AMENDMENTS TO THE DRAWINGS

REMARKS

Fig. 2

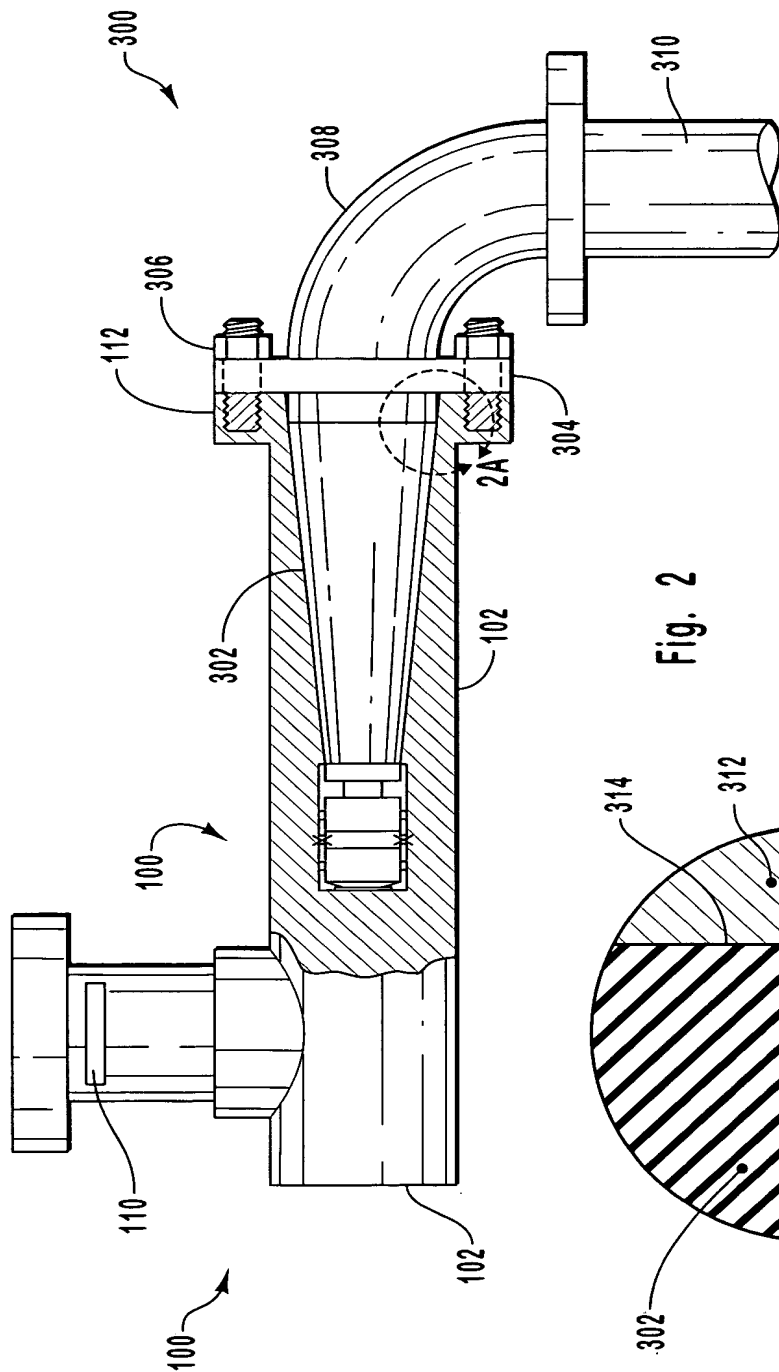
b. With respect to Figure 2, the Examiner has stated "The contact 108 is not shown in contact with electrical contacts 204C. It shows contacting the insulator 204D." In view of the replacement drawings submitted herewith, the objection has been overcome and should be withdrawn.

Fig. 2A

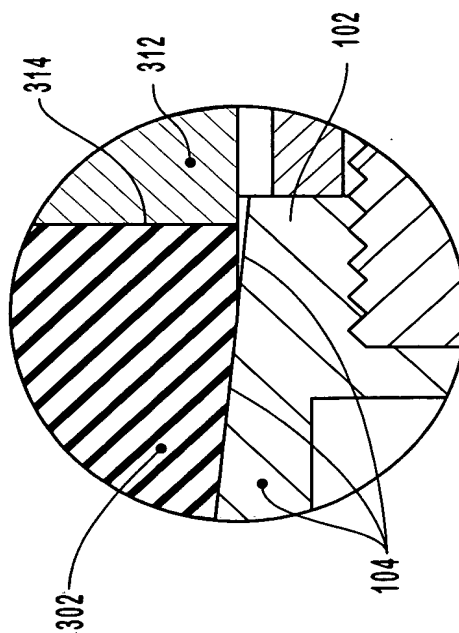
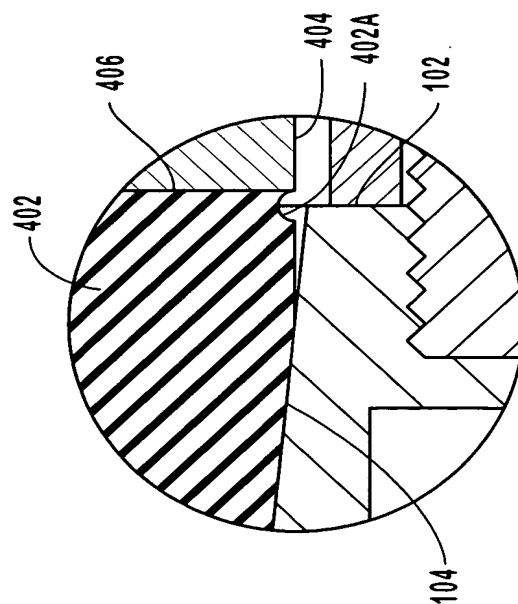
c. In connection with Figures 2A and 3A, the Examiner has stated "There are two elements in rightmost portion shown with different hatching. It is not clear if both of these are parts of the elbow fitting." Applicant disagrees and submits that the relation of the

aforementioned can be readily determined with reference to the specification. For example, the specification plainly refers to "... an interface portion 312 of the 90 degree elbow fitting 308," and to "terminal element 302." *Paragraph 0037. Emphasis added.* The specification further refers to "... a joint 314 ... cooperatively defined by the fitting 308 ... and the terminal element 302." *Id. Emphasis added.* Contrary to the assertion of the Examiner then, it is quite clear from the specification that "interface portion 312" is part of the "fitting 308," while the "terminal element 302" is not. Accordingly, no modifications are required to Figures 2A and 3A in this regard.

Fig. 3

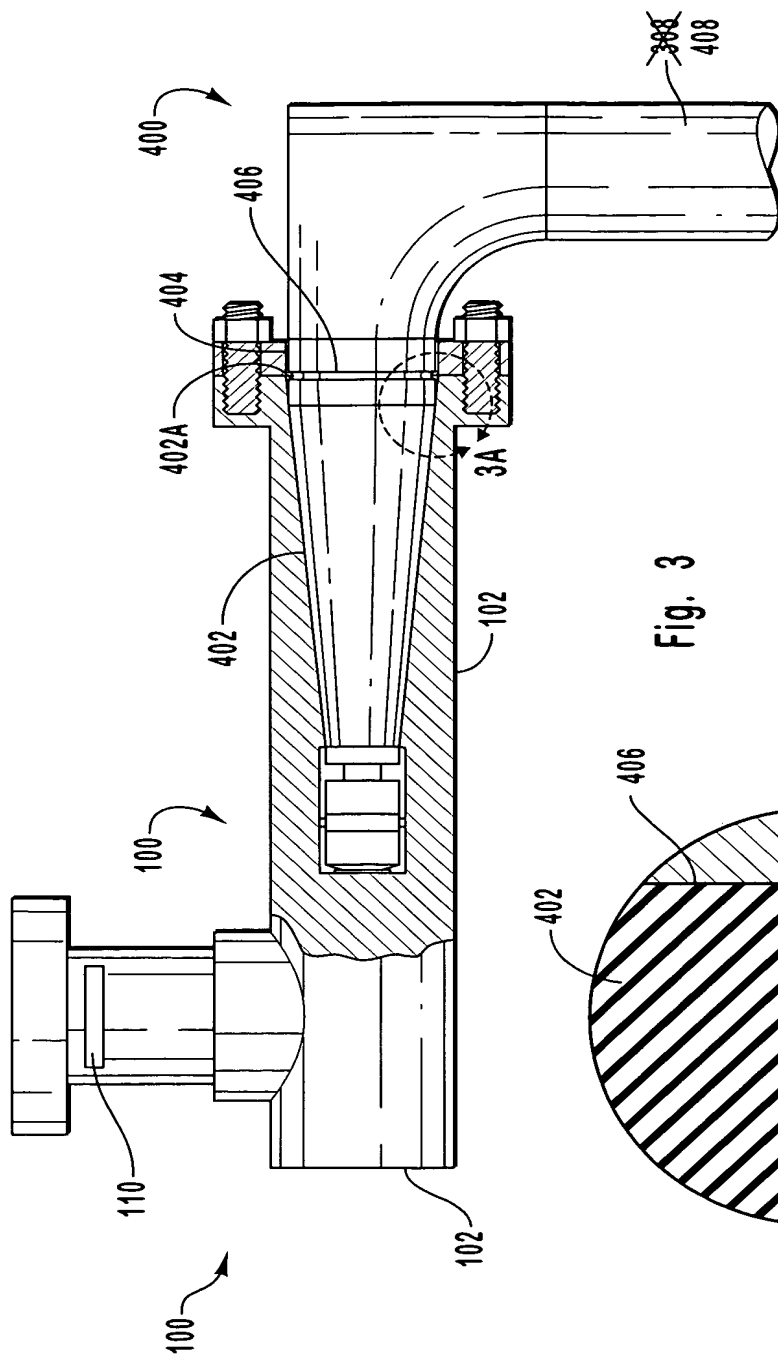
d. With regard to Figure 3, the Examiner has stated that "... '308' should be changed to '408'..." In view of the replacement drawings submitted herewith, the objection has been overcome and should be withdrawn.
